Project:	Highways England Spatial Planning Arrangement	Job No: 60600479 DM014.012
Subject:	South Caldecotte, Audit of revised forecast VISSIM model	
Prepared by:	Alejandro Pina Botella	Date: 26/06/2020
Checked by:	Javier Pardo	Date: 29/06/2020
Verified by:	Phil Arnold / Liz Judson	Date: 02/07/2020
Approved by:	John Alderman	Date: 03/07/2020

This Technical Note describes the modelling audit of the South Caldecotte forecast Vissim models of the A5/A4146 Kelly's Kitchen Roundabout, provided by BWB to support the planning application of the proposed South Caldecotte development in Milton Keynes. The audit was carried out based on WebTAG guidance and best practice recommended in Transport for London (TfL) Traffic Modelling Guidance.

Figure 1. Detectors added on south stream 2, signal controller 5.

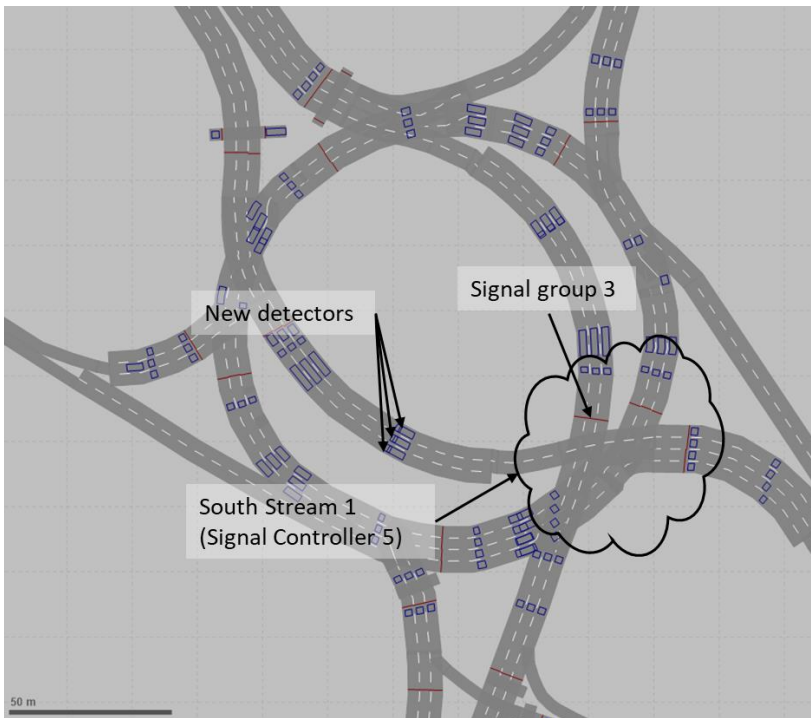
A change in the operation of signal controller 'South Stream 1' has been introduced in all scenarios, including the addition of new detectors into the Kelly's Kitchen Roundabout (as shown in Figure 1), which help to manage the queues inside the roundabout. This is considered appropriate.

The only changes in signal controllers across the modelled scenarios are maximum and minimum green times, which are considered appropriate changes for signal timing optimization. Signal Controller 5 (South Stream 1) is forced to run for 7 seconds (maximum green time of 7 seconds) in the Do Something scenarios.

Figure 4. AM Peak model observations

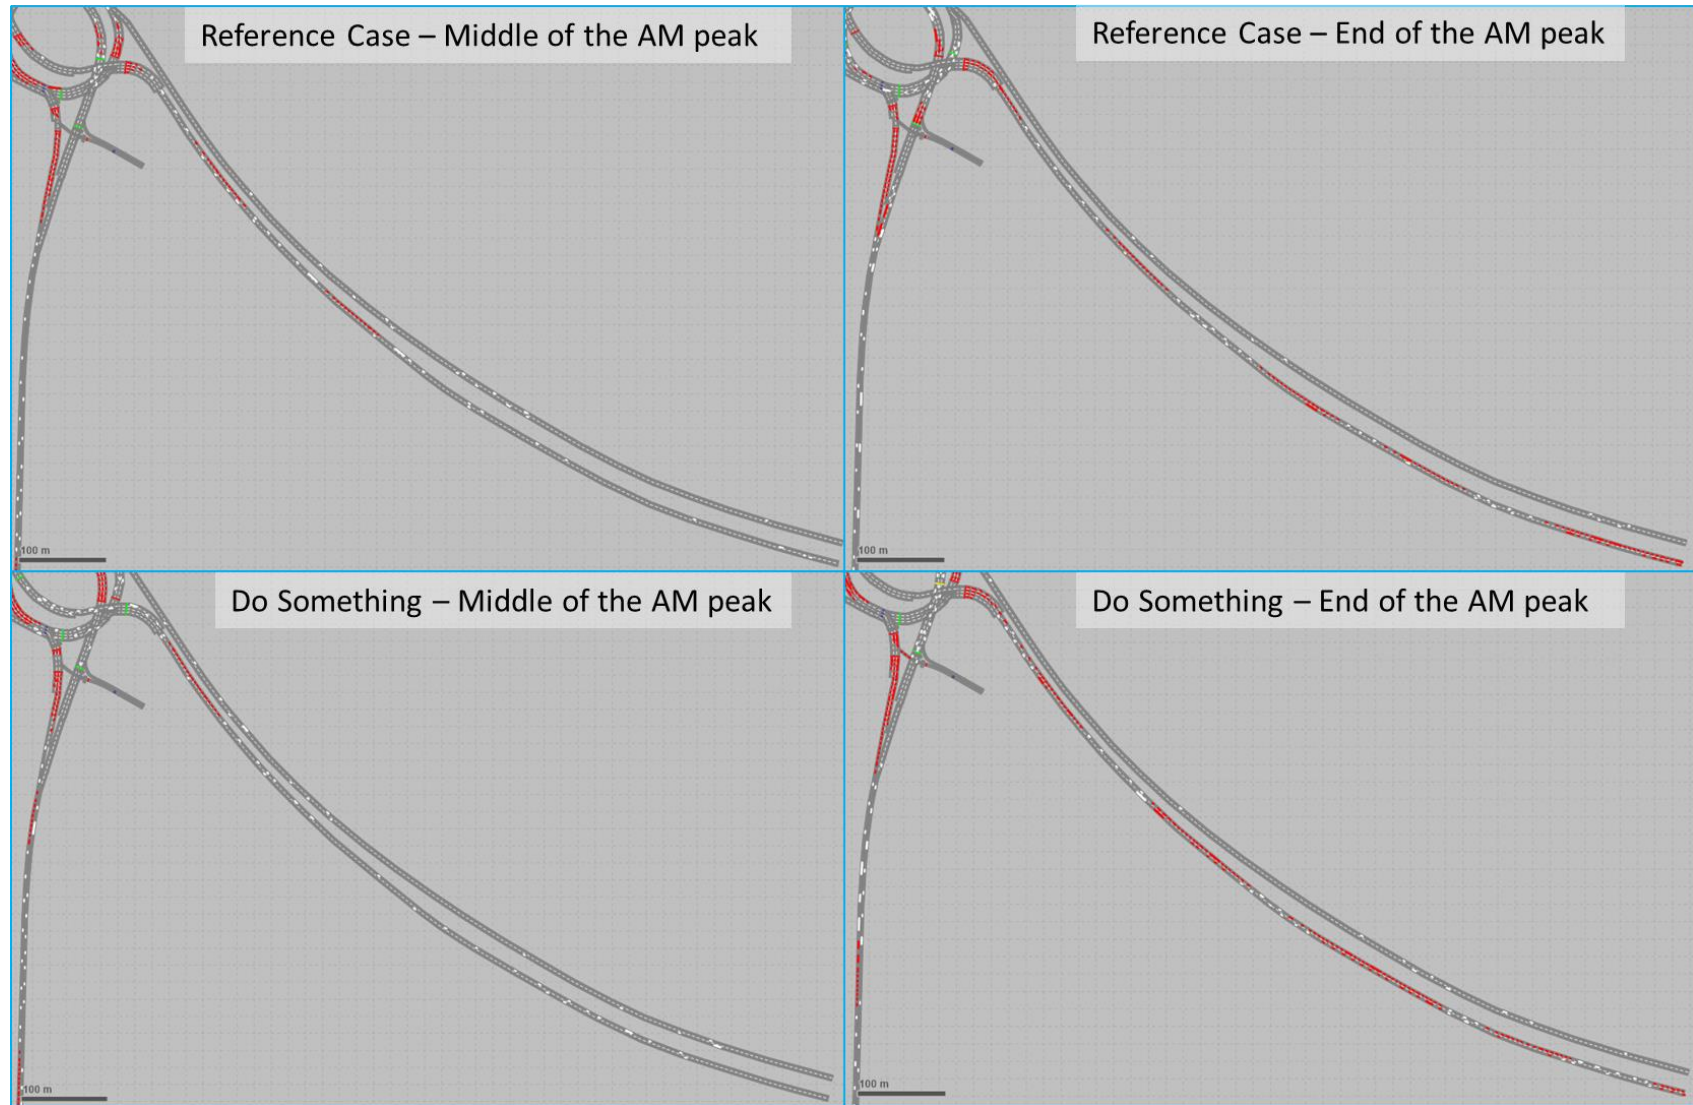
The previous review highlighted a significant increase in queues during the AM peak on the A5 northbound in the Do Something scenario compared to the Reference Case. Observation of the updated model runs shows consistent levels of congestion on the A5 northbound in the Reference Case and Do Something scenarios (as

shown in Figure 4).

Figure 7. Network Performance results for total delay¹ including latent delay.

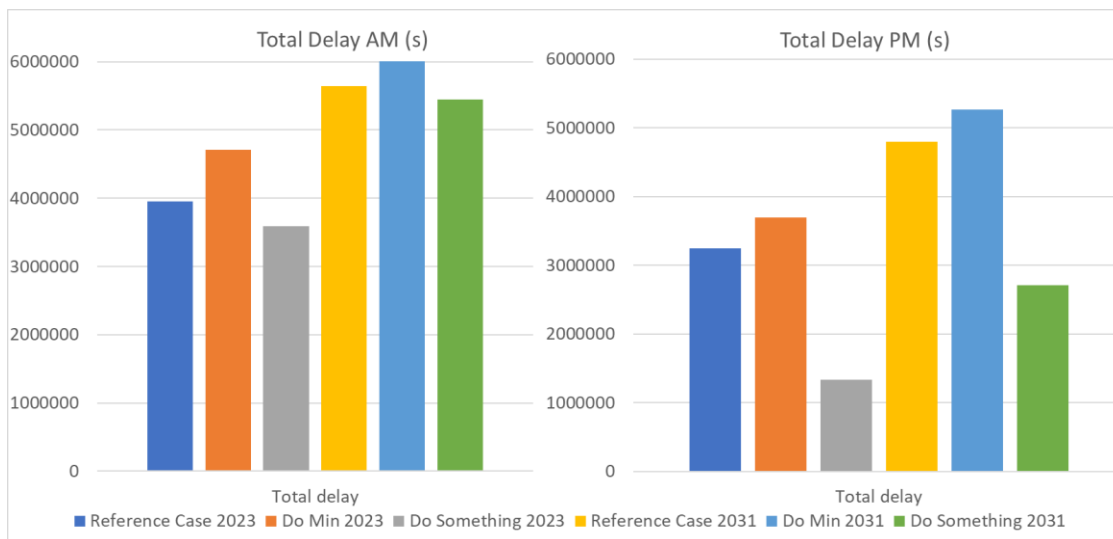
There is predicted to be a significant reduction in overall average delay and latent demand with the implementation of the proposed mitigations (comparison between Reference Case, Do Minimum and Do Something).

The Total Delay figures include the delay experienced by all vehicles loaded in the network, plus the delay experienced by vehicles that could not be loaded on to the network during the simulation. The results indicate that the additional delay caused by the development in the AM peak hour is effectively mitigated in the Do Something Scenario. The results also show that there is less delay in the Do Something scenarios compared to the Reference Case scenarios in the PM peak hour.

It should be noted however that this assessment includes the mitigation at the Tilbrook Roundabout. The latent demand indicates, that due to congestion, not all vehicles are able to enter the model network.
